Attachment B
Early Scoping Comments

Enclosed are my personal comments regarding the Buffalo Bayou and Tributaries Resiliency Study that the U.S. Army Corps of Engineers (Corps), Galveston District, along with the local sponsor, Harris County Flood Control District (HCFCD), is conducting. Since I will be on vacation for three weeks, I am providing these comments early. I have no information about the study but will provide you with some thoughts about flood control in the Buffalo Bayou Watershed.

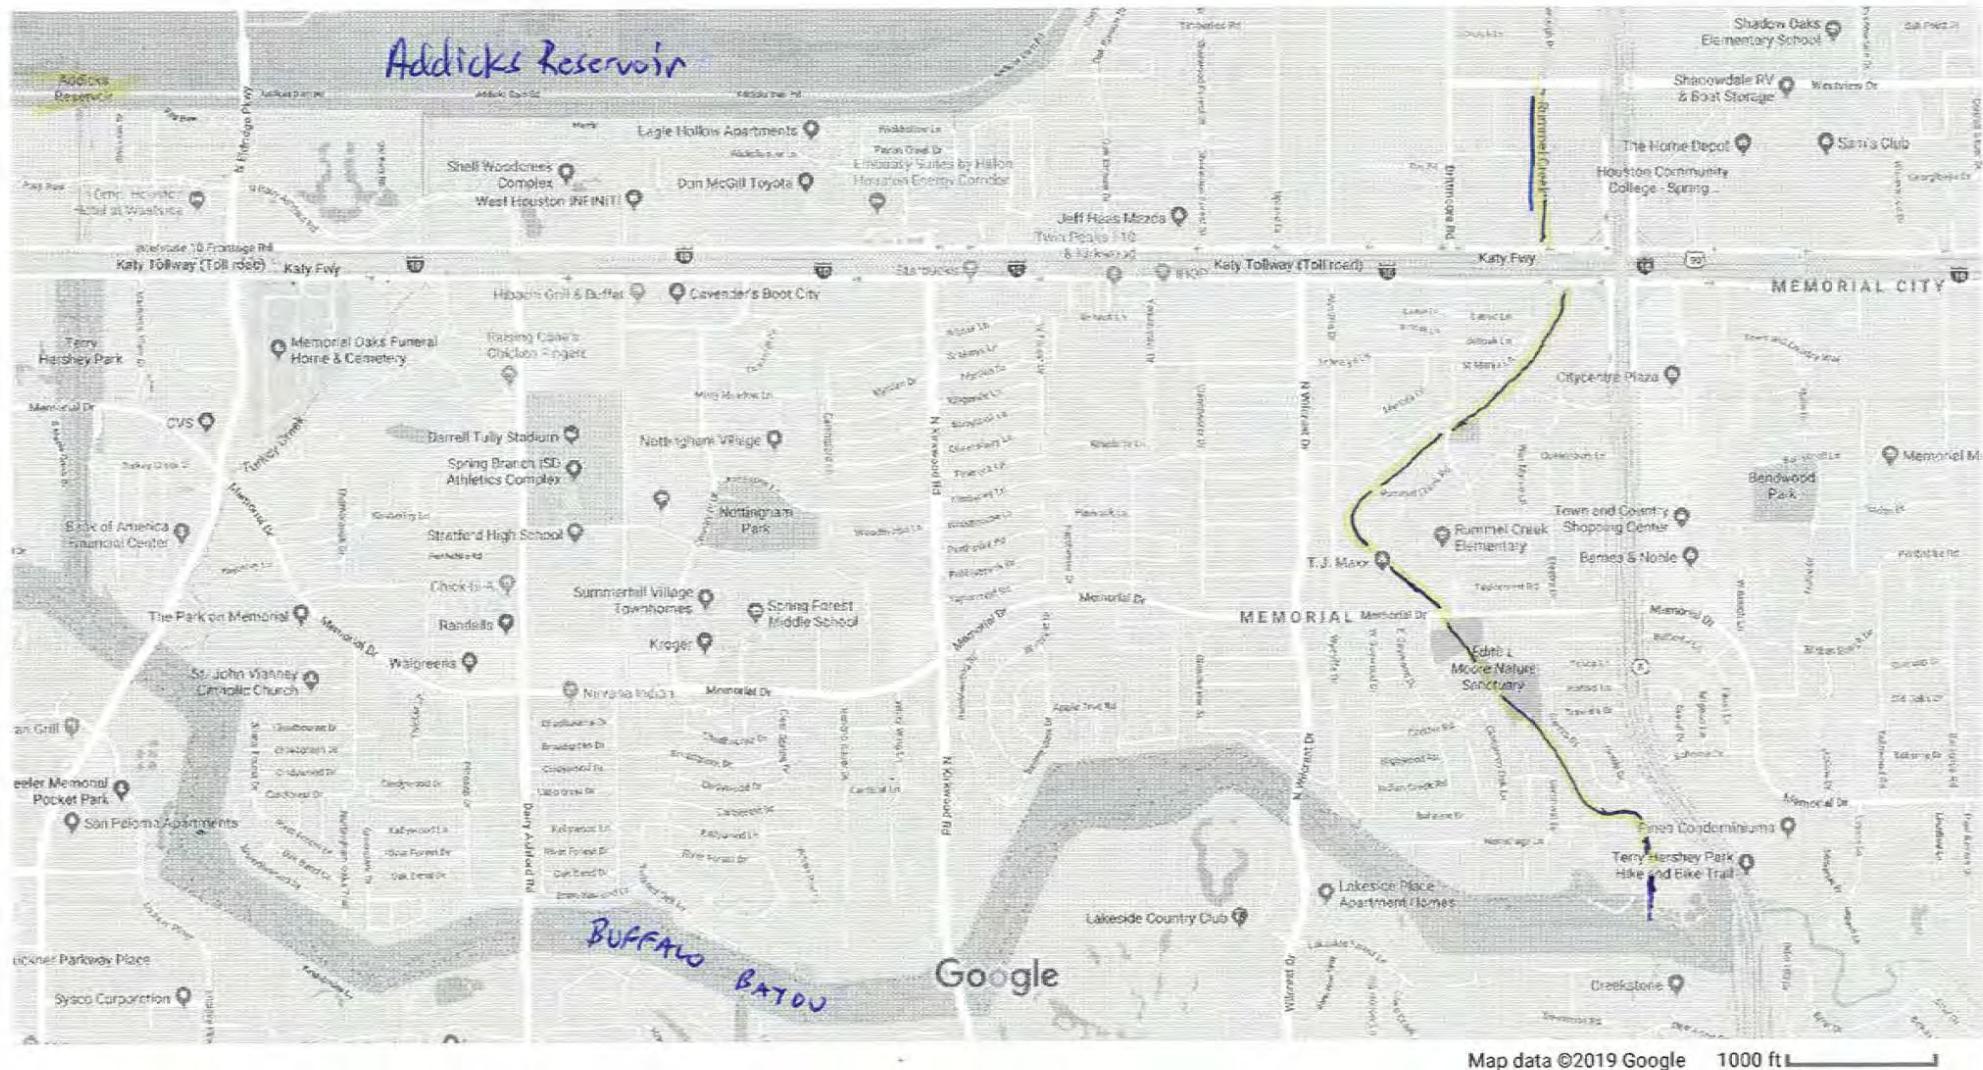
The creek has a right-angle turn, to the west of Rummel Creek Elementary, which impedes its flow.

Please evaluate the resiliency of Rummel Creek in your study.

Oxbow Relief – *a high flow bypass*

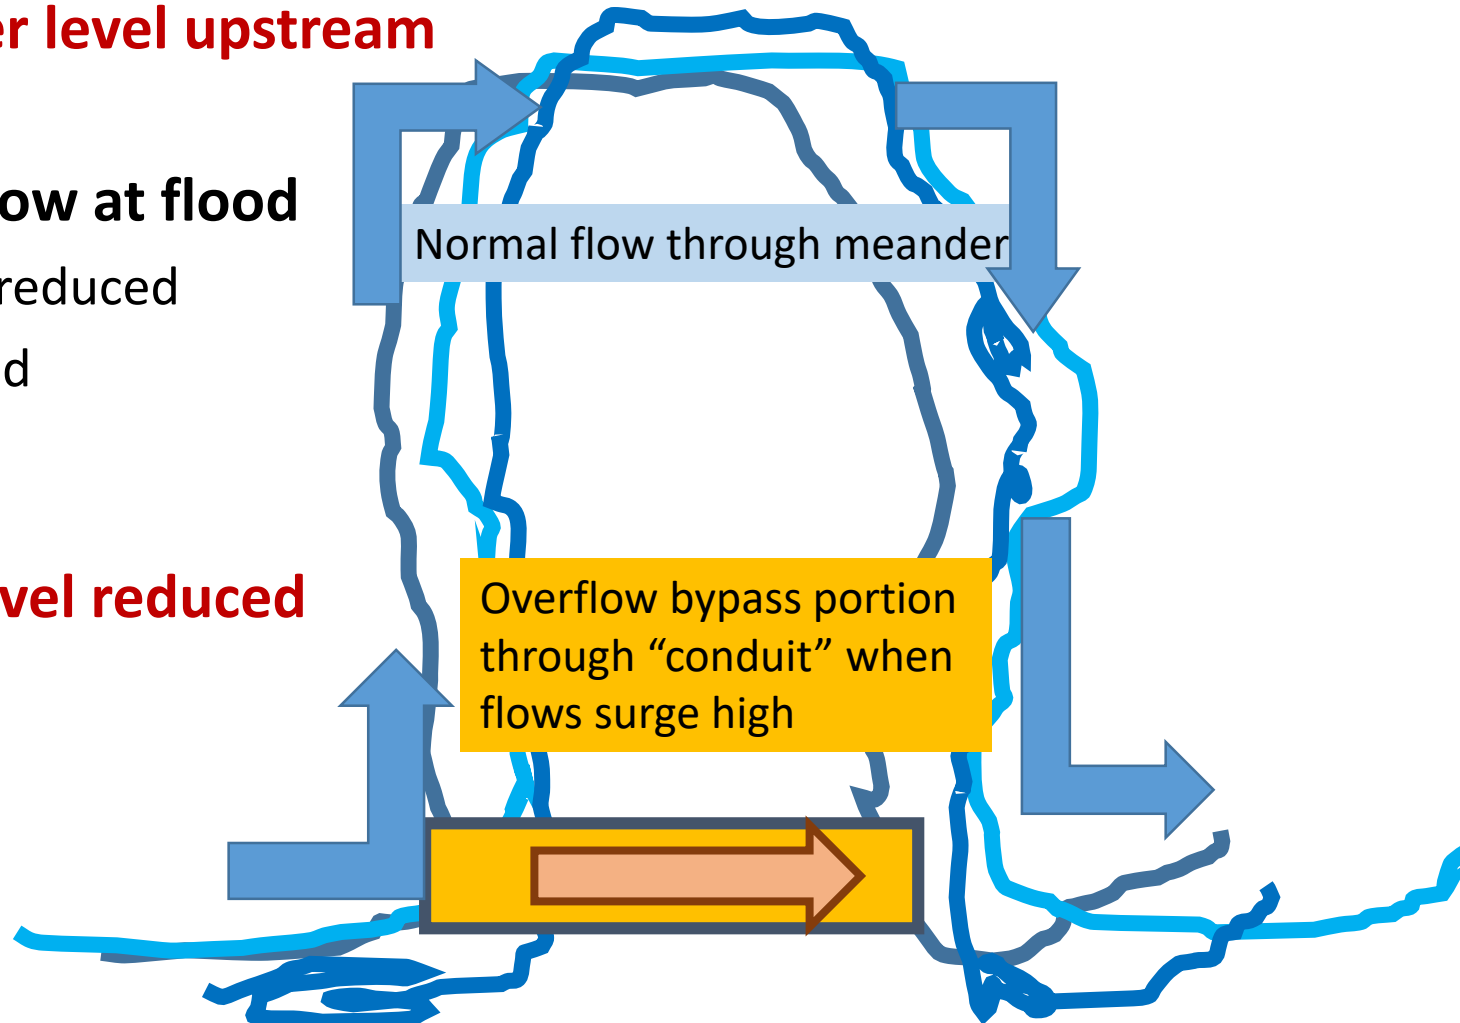
Water at oxbow makes 360 degree turn

- Head loss ($V^2/2g$ + friction)
increases water level upstream

- Erosion at turns

Overall water level reduced

Bridges Impede Flow – Wilcrest to Shepherd

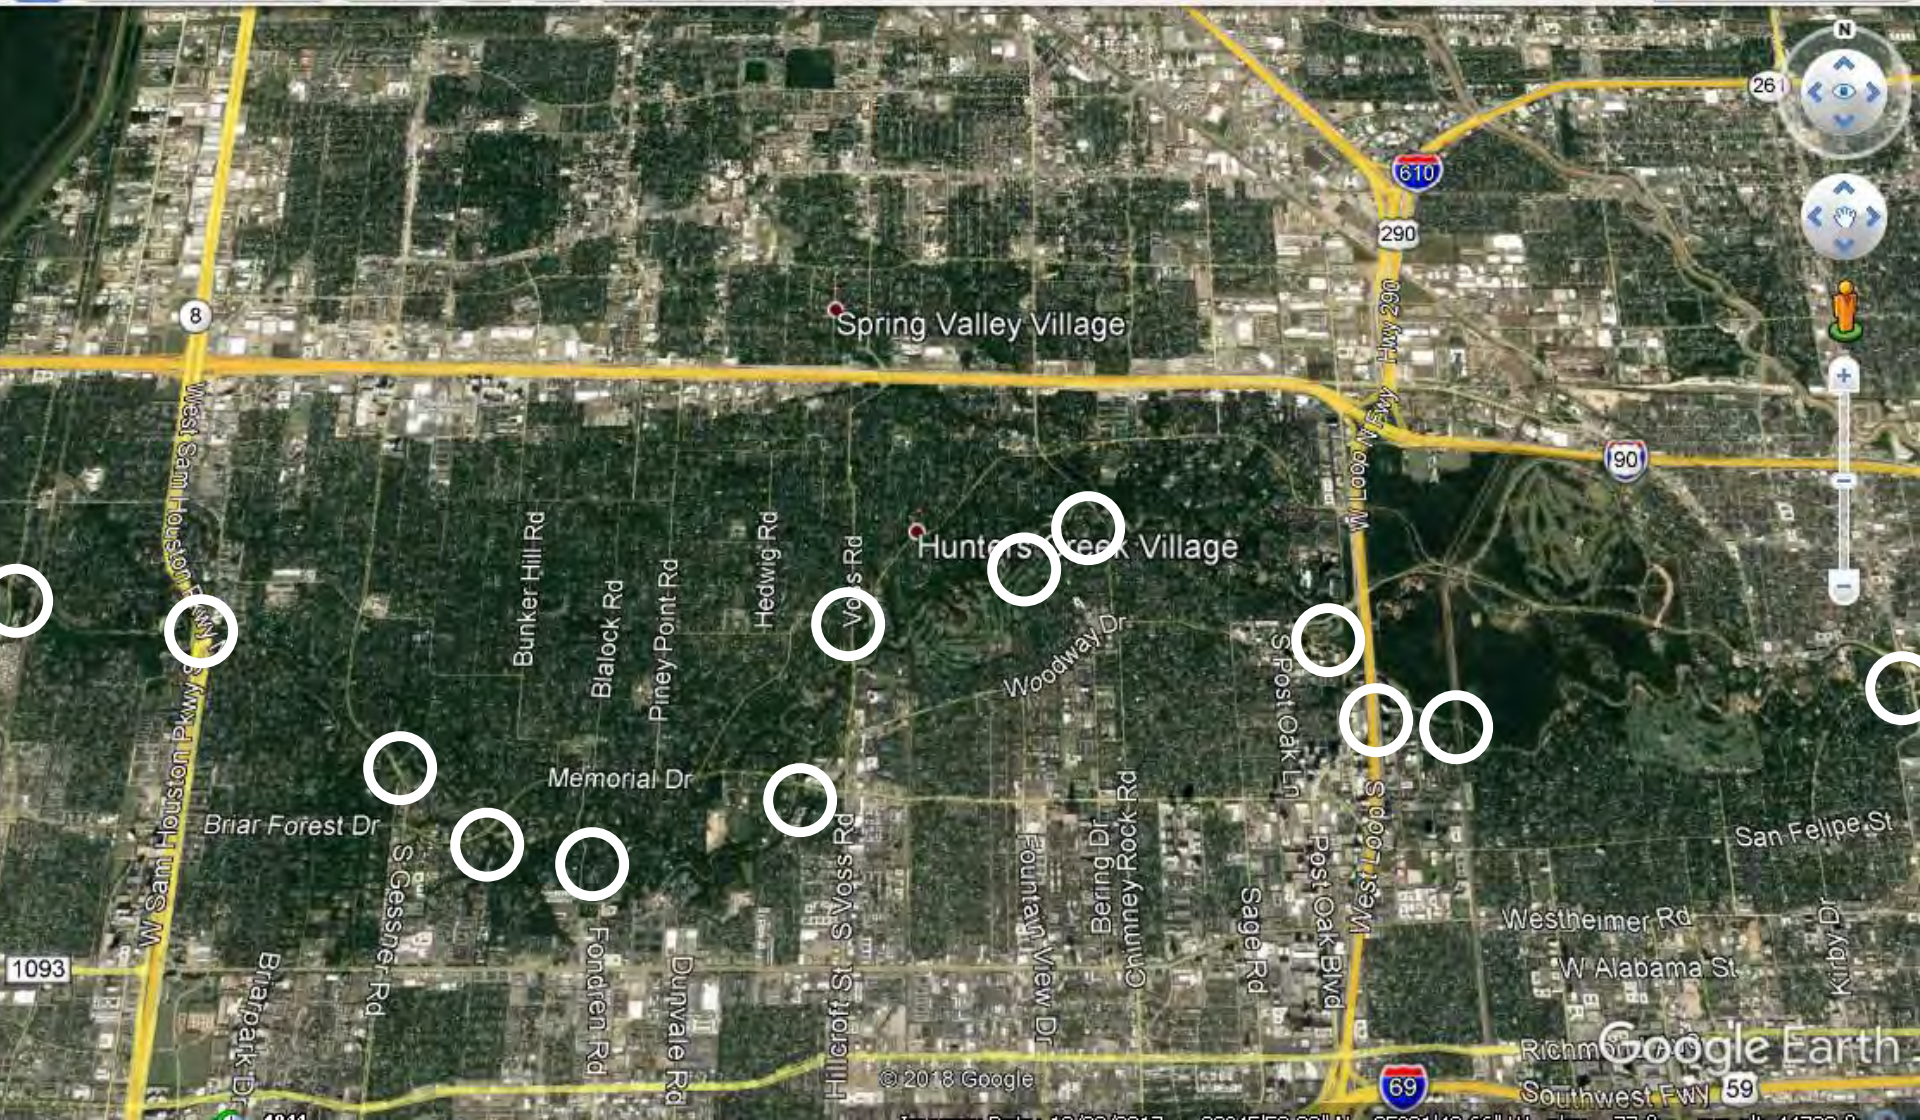
Bridge	event year	level	10	50	100	500
• Gessner	-	-	-	1	3	7
• Briar Forest	-	-	-	-	-	3
• S. Piney Point	-	-	-	-	-	2
• San Felipe	-	-	-	-	1.5	6.5
• Voss	-	-	-	-	-	2
• Further Point	-	-	-	-	1.5	6.5
• Chimney Rock	-	-	-	-	-	2
• Woodway	-	-	-	-	2.5	7.5
• I-610	-	-	-	-	-	5

Bridge elevations basis FEMA Flood Insurance Study Harris County January 2017
Event basis: United States Geological Service Report (USGS), Asquith (1988)

Bridges East of Shepherd , Downtown

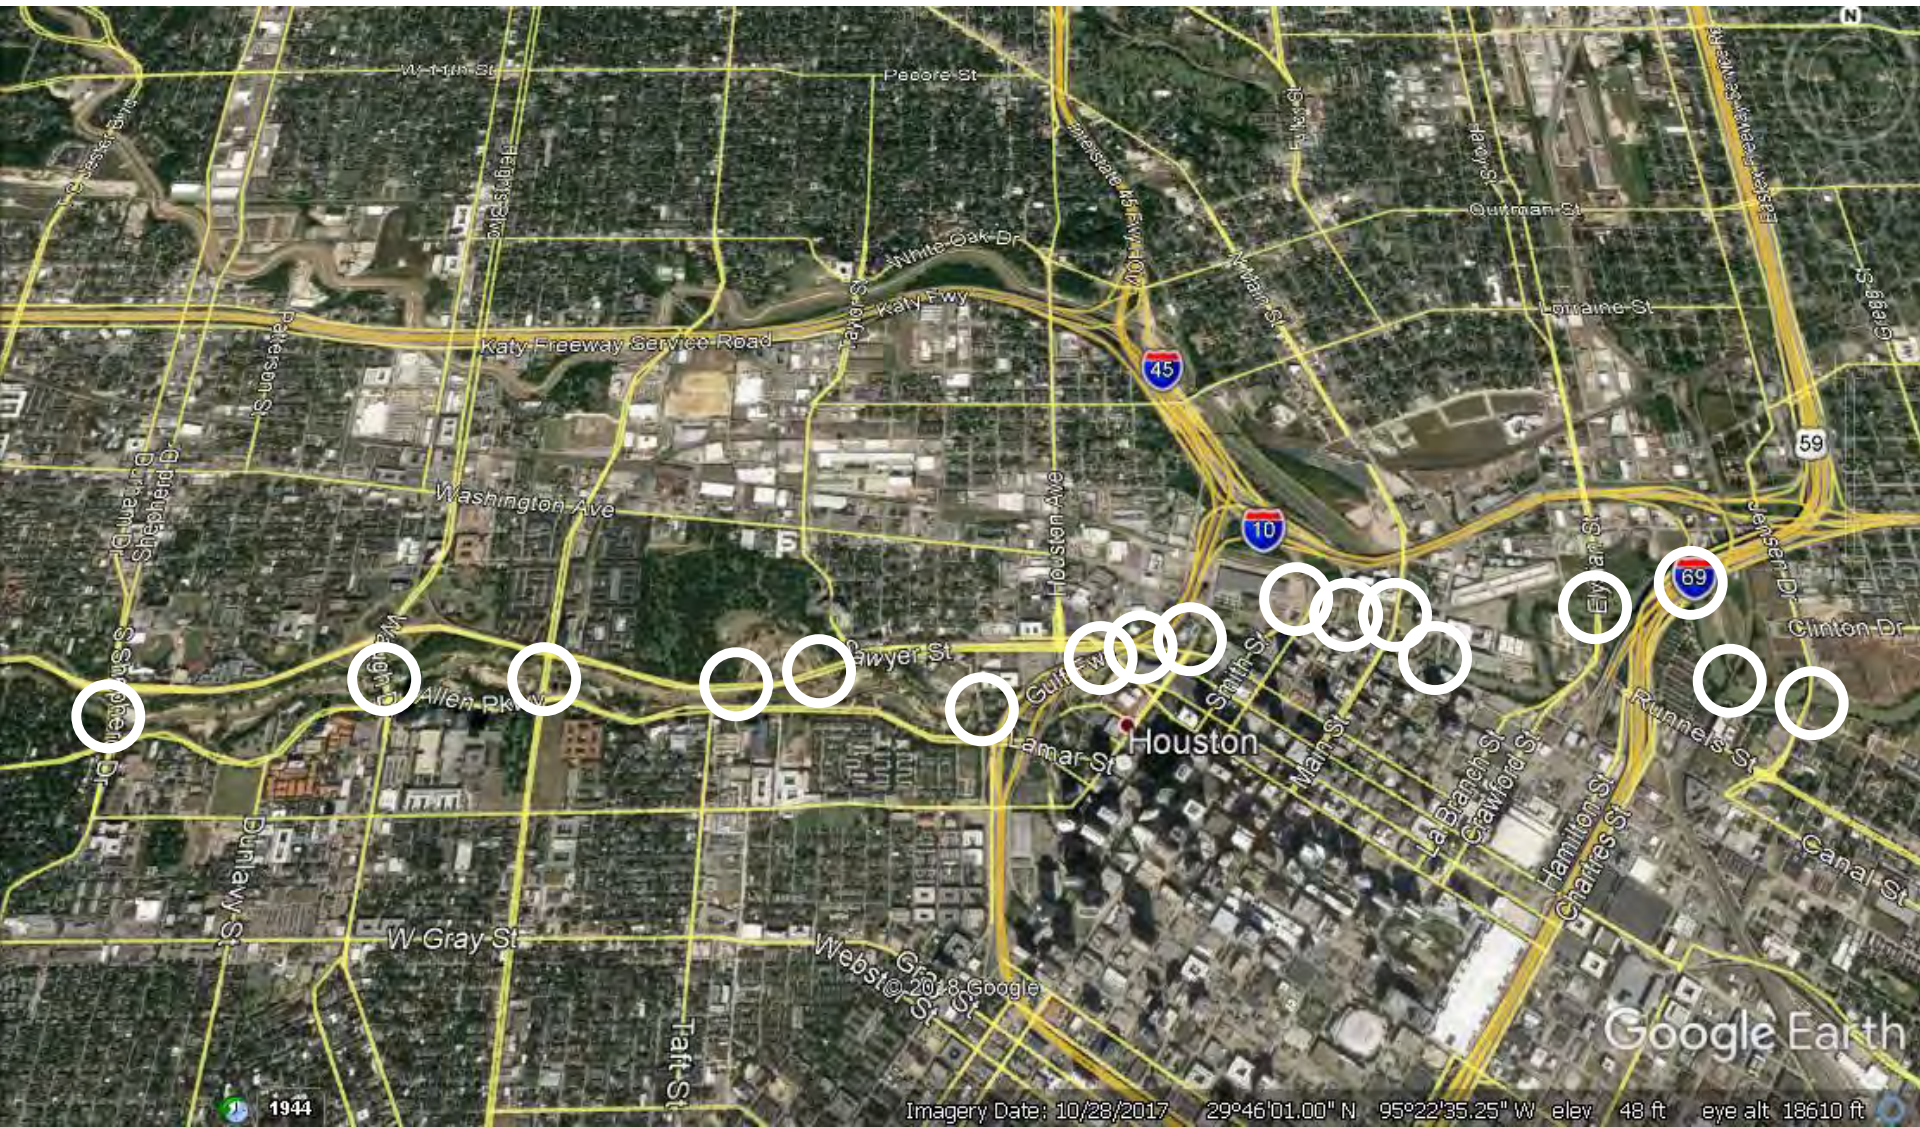
Bridge	event year	level 10	50	100	500
• Shepherd		-	-	1.5	7.5
• Waugh		-	-	-	4
• Montrose		-	-	1	7
• Memorial		2	6	9	15
• Memorial		4	8	11	17
• Texas/Sabine		-	-	2	7
• Louisiana /Franklin/ Capital/Allen		-	5.5	8.5	13.5
• Milam		7	11	14	19
• Travis/Smith/Preston		-	4	7	12
• Prairie/Bagby		-	-	0	5
• Congress		-	1.5	4.5	9.5
• Main		-	-	-	-
• Fannin		-	-	0	5
• San Jacinto		-	-	1.5	8
